# Service Bulletin

## SAFETY and EMISSIONS RECALL

### 2014 Grom125 FUEL PUMP REPLACEMENT

### Set, Fuel Pump Unit Assy. (1)

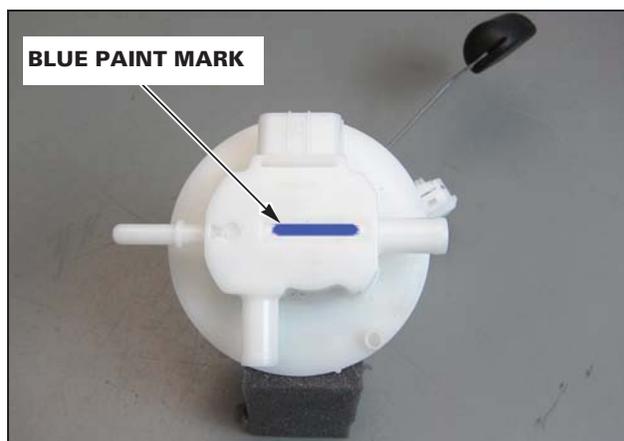
Be careful not to mix up the defective and replacement parts. The countermeasure part is identified by a blue paint mark as shown. Use care during unpacking and installation as the paint mark is easily wiped off.

P/N 06160-K26-306

Fuel pump unit assy.,	P/N 16700-K26-305
Dust seal,	P/N 17573-K26-900
Fuel pump gasket,	P/N 17572-K26-900
